Wholesale Electricity Market Rule Change Proposal Submission

RC_2019_05

Amending the Minimum STEM Price definition and determination

Submitted by Economic Regulation Authority

Figure 1. Stylised distribution of minimum energy supply cost.

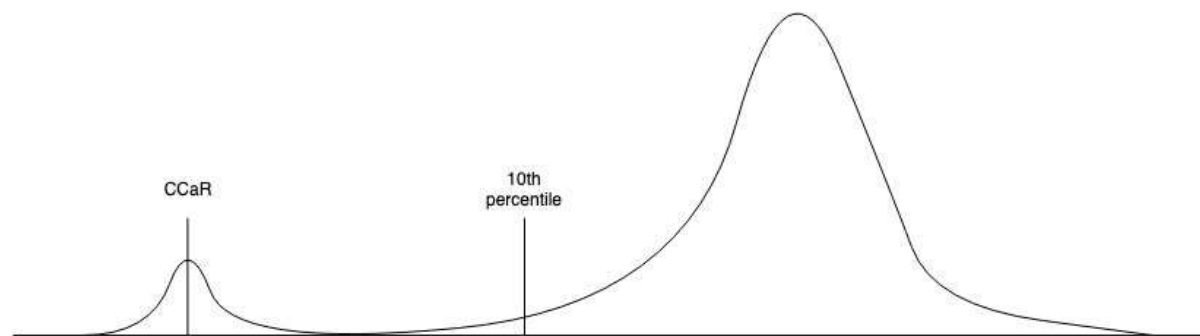
The possible inclusion of several facilities’ costs in the calculation and variability of those costs can result in a distribution of minimum supply costs with a bi-modal or multi-modal shape and a long tail on the negative side, as shown in the stylised diagram in Figure 1. In the tail of the distribution, the possible minimum supply costs are, on average, substantially lower than the 10th percentile of the distribution.

The selection of the 10th percentile for setting the price floor appears arbitrary. For example, generators with high cycling costs would be willing to receive a more negative price (pay more to buyers) below the price floor to avoid the higher cost of cycling. With a price floor set at the 10th percentile these generators will incur losses.

The price floor calculation should account for very low supply costs, so the benefit of low wholesale prices can be passed on to consumers. One possible approach is to calculate the 10 per cent conditional cost at risk, identified in Figure 1 as CCaR.
